**REQUEST**

Current Zoning: O-1 (office) and I-1 (light industrial)  
Proposed Zoning: UR-2(CD) (urban residential, conditional)

Approximately 10.09 acres located on the south side of Milton Road and west side of Barrington Drive, northwest of North Sharon Amity Road.

The petition proposes to allow a 168-unit multi-family residential community on vacant land.

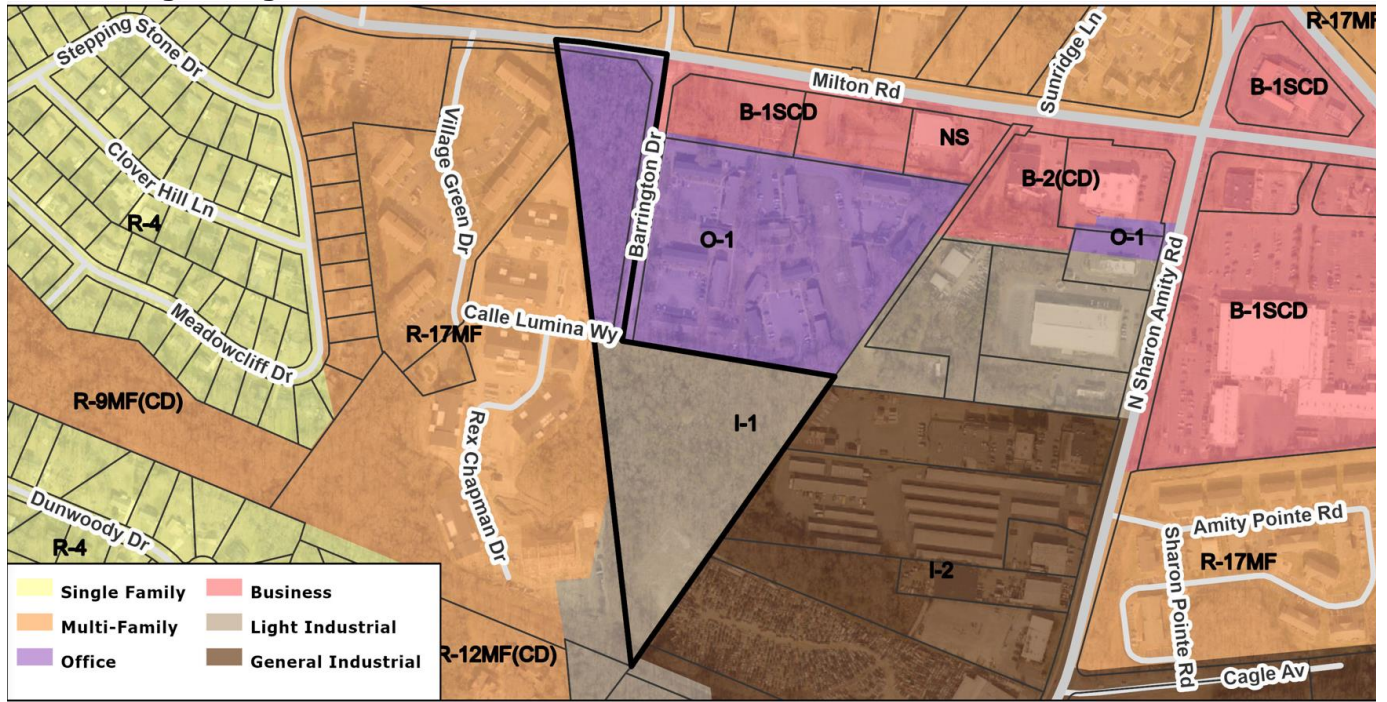
3. ~~The farthest portion of a residential building must be within 400 feet of vehicular access from a public right-of-way or private street per Section 9.303(19)(c). Building at top left of site appears to not meet this standard.~~ Addressed (petitioner provided measurement acknowledging adherence).
4. ~~Modify language to reference a 50-foot Class A buffer, reduced to 37.5 feet with a wall or a fence.~~ Addressed
